EVMK2E Known Issues

SR No#	Issue Detail	Affected Board Version No.	Resolved Board Version No.
1	USB Supply Issue	EVM v 1.0.2.0	EVM v 1.0.2.1 (Beta) and onwards
2	CP2105 (USB to Dual UART Convertor) Serial COM ports does not work when inserted into AMC chasses	EVM v 1.0.2.0	EVM v 1.0.2.1 (Beta) and onwards
3	SATA detection Issue	EVM v 1.0.2.0 and EVM v 1.0.2.1	EVM v 1.0.2.2 and onwards
4	Leakage voltage at VCC3V3 Aux line generated when EVM inserted in AMC chassis.	EVM v 1.0.2.0, EVM v 1.0.2.1 and EVM v 1.0.2.2	EVM v 1.0.3.0 onwards
5	USB 3.0 Link Error Issue	EVM v 1.0.2.0, EVM v 1.0.2.1, EVM v 1.0.2.2 and EVM v 1.0.3.0	EVM v 1.0.3.1 onwards
6	USB 3.0 Software Patch for EVM v 1.0.3.1	EVM v 1.0.3.1	
7	XDS200 Firmware Issue	EVM v 1.0.2.0, EVM v 1.0.2.1, EVM v 1.0.2.2, EVM v 1.0.3.0 and EVM v 1.0.3.1

1. USB Supply Issue

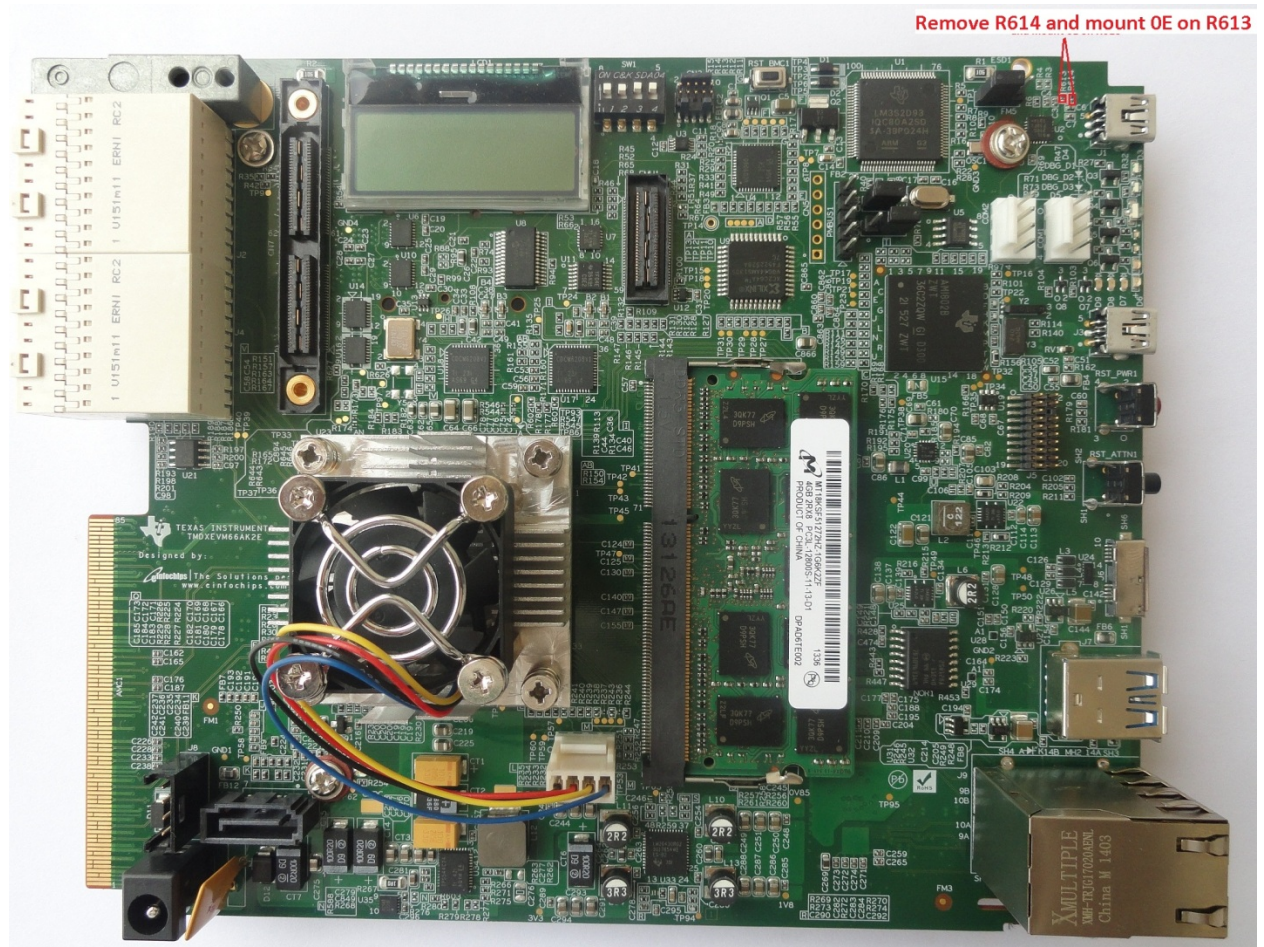
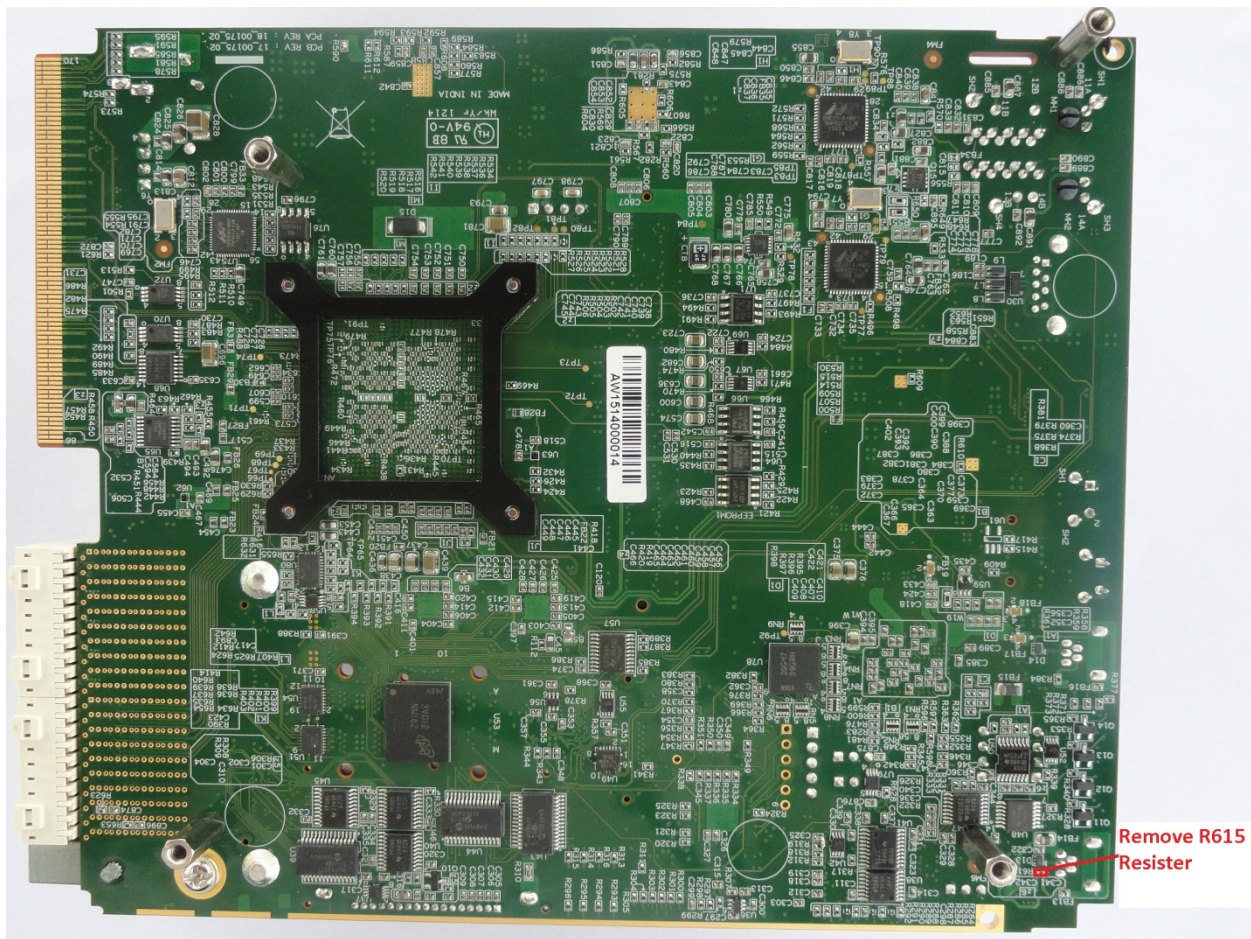
In Alpha boards (EVM v 1.0.2.0) TPS22913 Enable signal (USB_VBUS_EN) not provided in V01 UCD9090 configuration. Please update latest UCD9090 XML File (XML v2 or higher) from below link.

This issue is resolved from EVM v 1.0.2.1 (Beta) and onwards.

3. SATA detection Issue

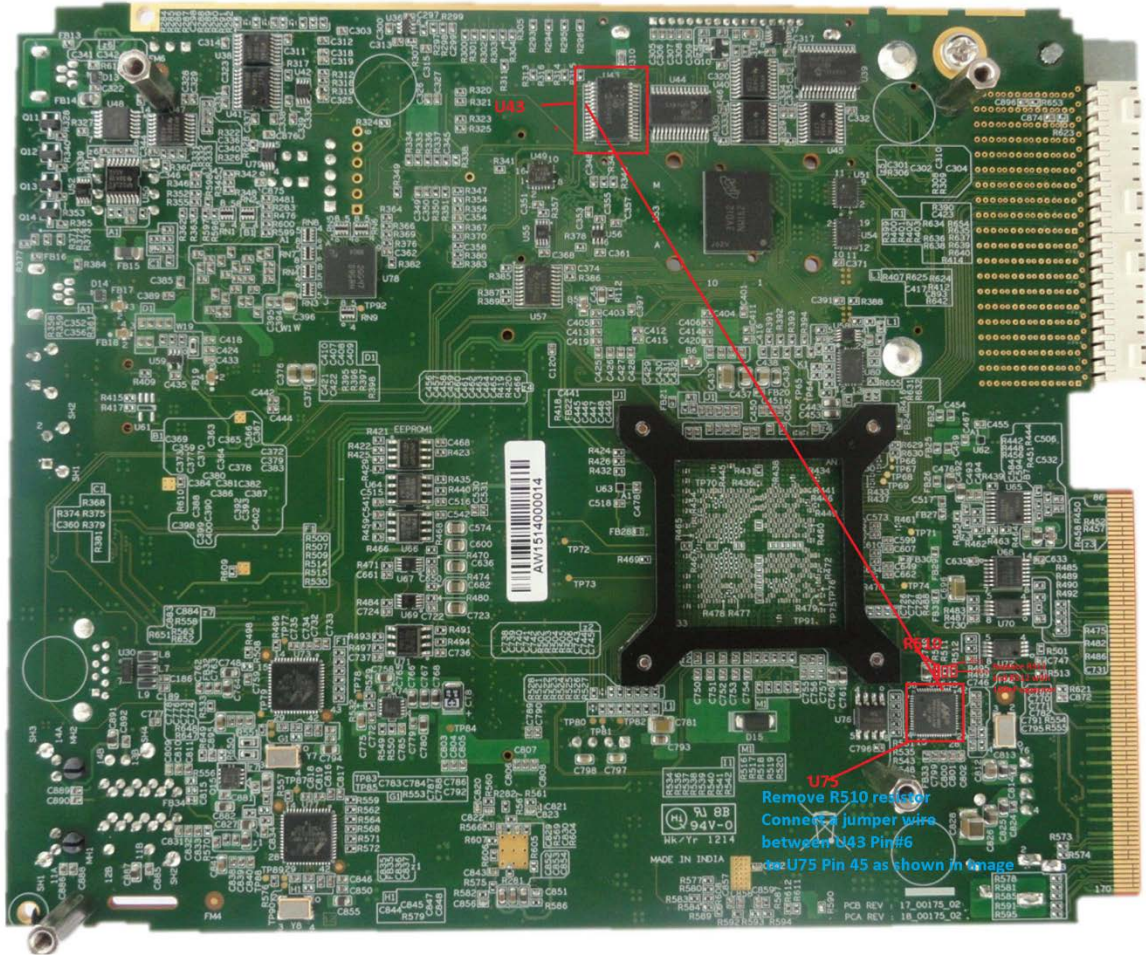
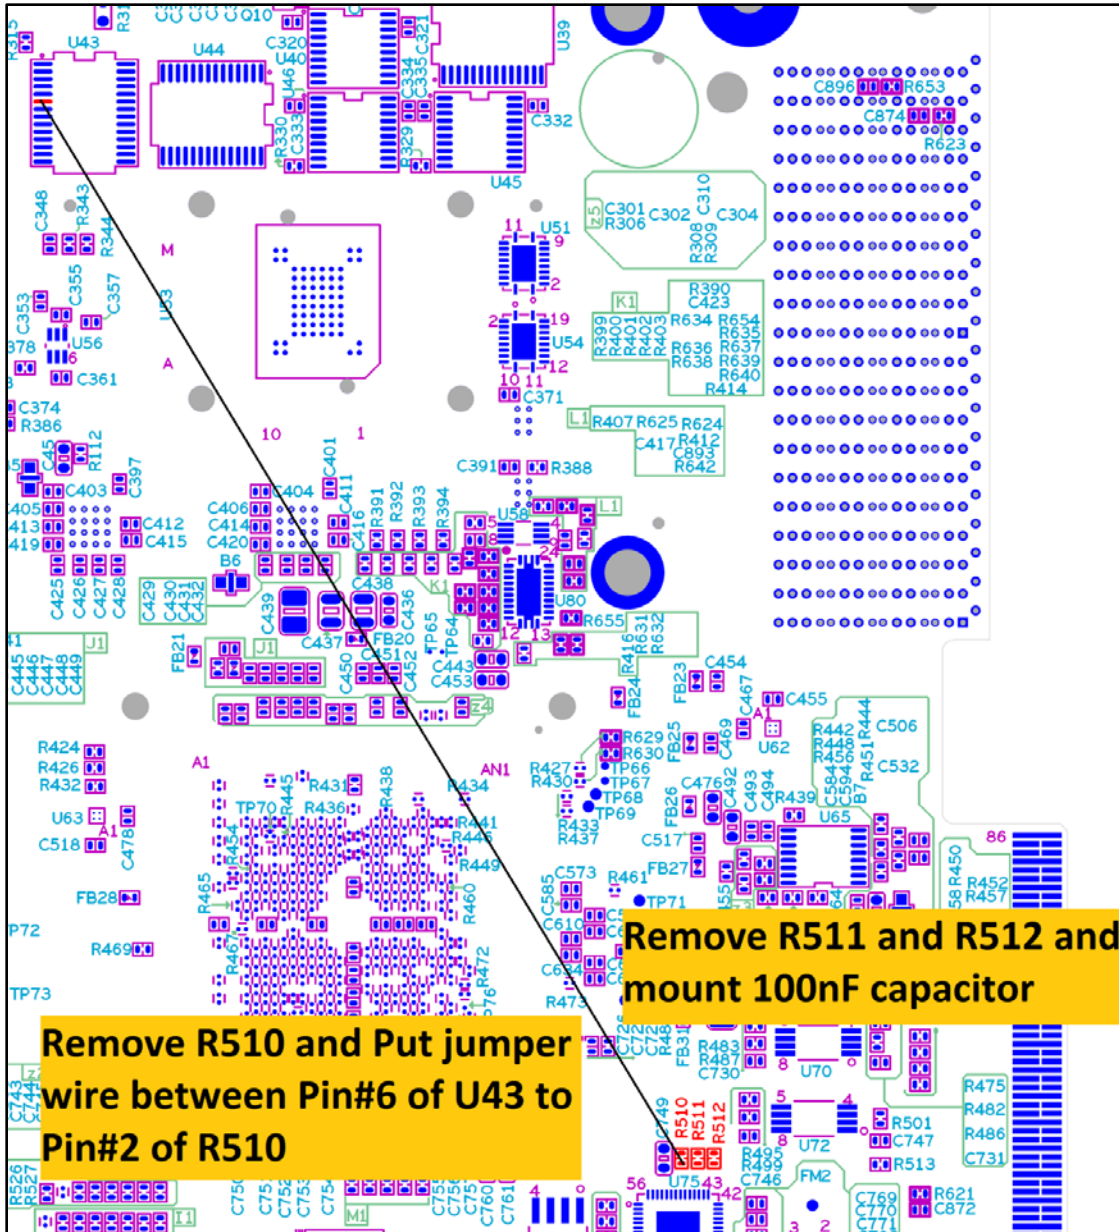
In Alpha & Beta (EVM v 1.0.2.0 and 1.0.2.1) version of EVMs are not supported to SATA devices. Please remove R510 and put a jumper wire between Pin#6 of U43 to Pin#2 of R510 as shown in below Image. Please replace R511 and R512 with 100 nF capacitors as shown in below Image.

This issue is resolved from EVM v 1.0.2.2 (Beta) and onwards.

4. Leakage voltage at VCC3V3_Aux line generated when EVM inserted in AMC chassis.

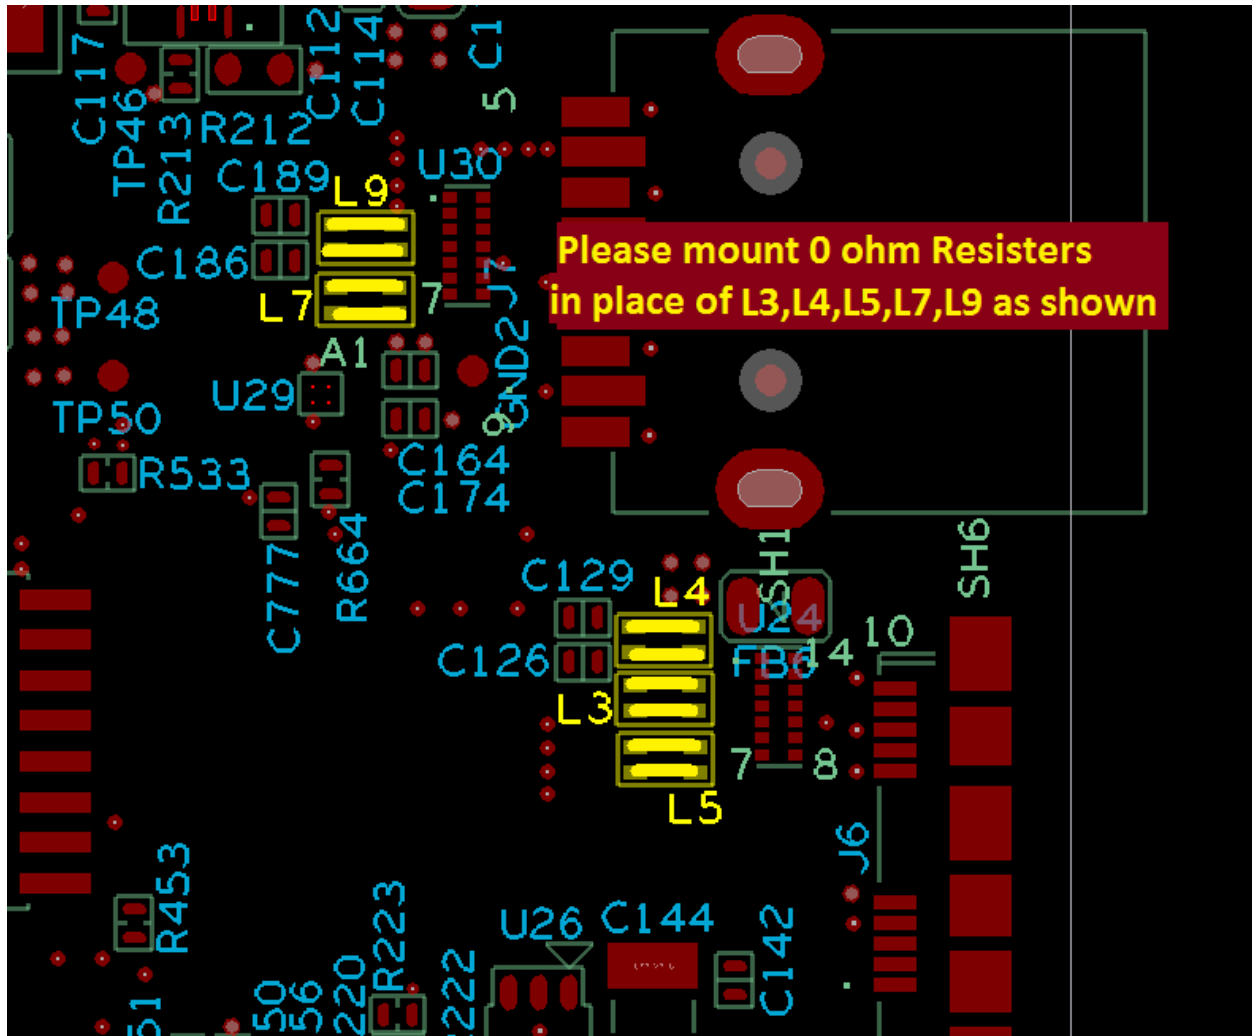
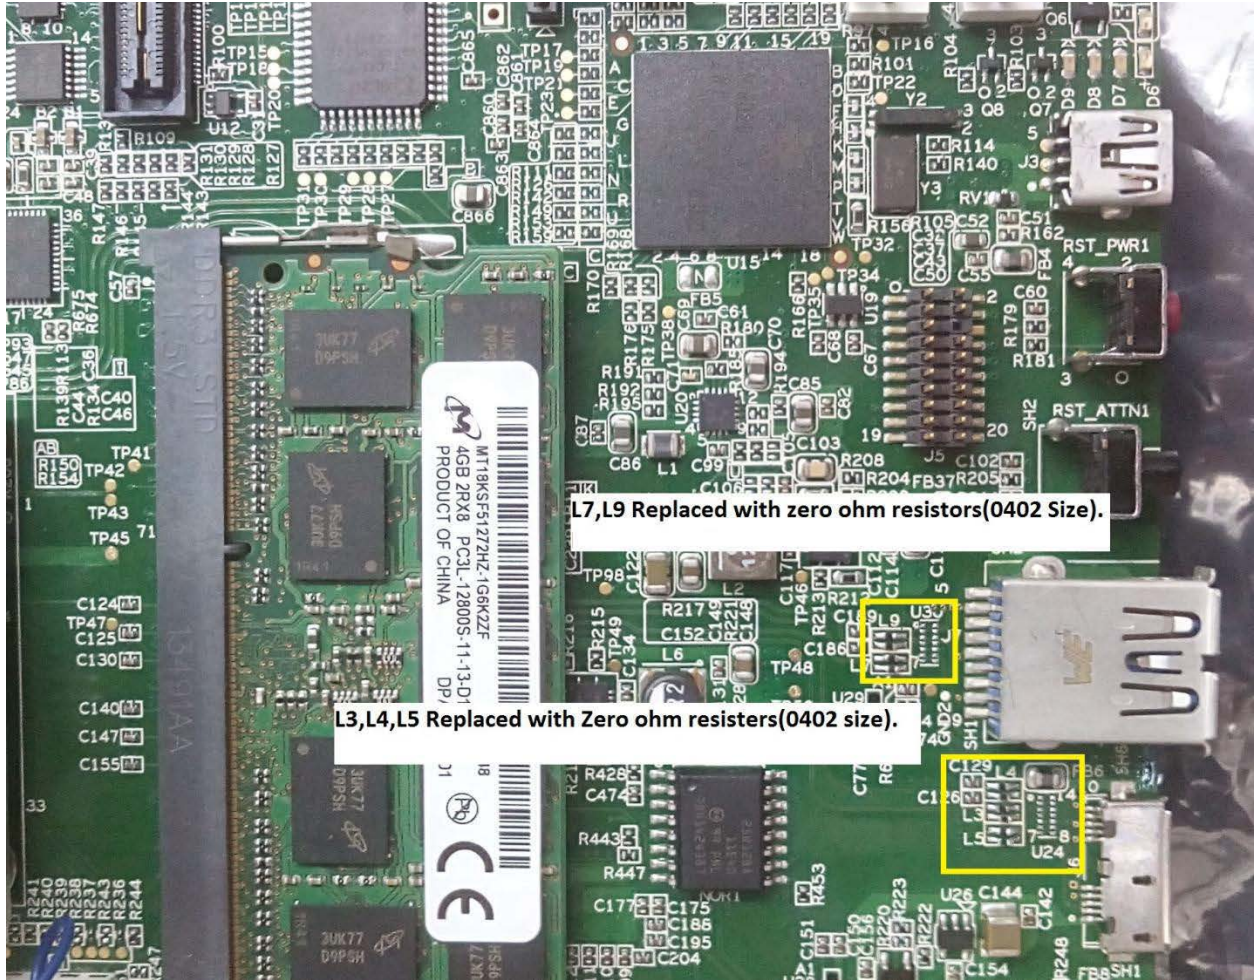
All versions of EVM, We have observed 0.95V Leakage on VCC3V3_AUX power rail during VCC_3V3_MP power is present.

Please update latest Board Management Controller Binaries (BMC v. 1.1.0.5 or higher) Source Code from below link.

5. USB 3.0 Link Error Issue.

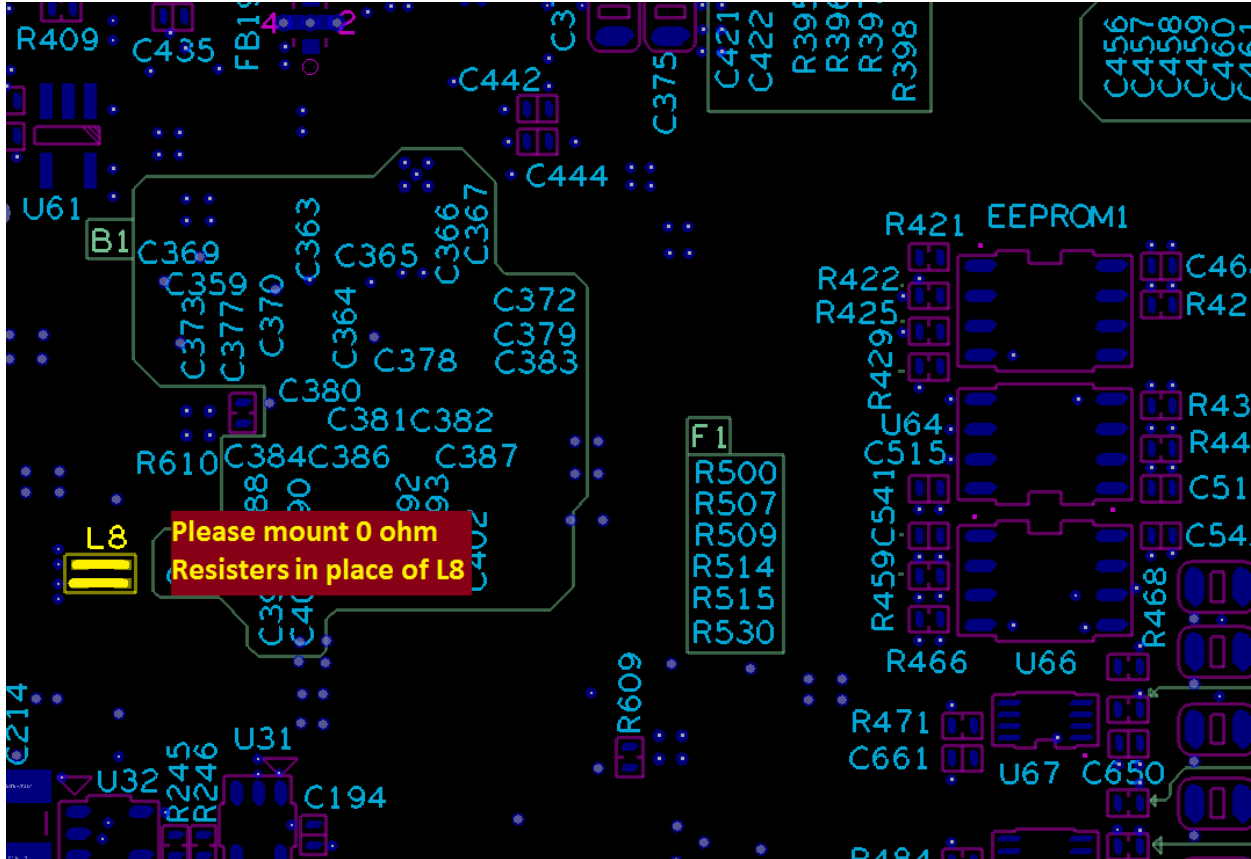
We have observed USB 3.0 link errors on K2E EVM board using USB protocol analyzer tool. EVM v 1.0.2.0, EVM v 1.0.2.1, EVM v 1.0.2.2 and EVM v 1.0.3.0 versions of EVMs are affected by USB link Issue. Both USB 3.0 ports of EVMs are affected by link error issue. These links errors point to some USB signal integrity issues on K2E and are causing issues in the driver functionality. Please find related hardware changes as below.

Please mount zero ohm resistors (0402 size) in place of L3,L4,L5,L7,L9 at (top side of board) as shown in below images.

L7,L9 Replaced with zero ohm resistors(0402 Size).

L3,L4,L5 Replaced with Zero ohm resistors(0402 size).
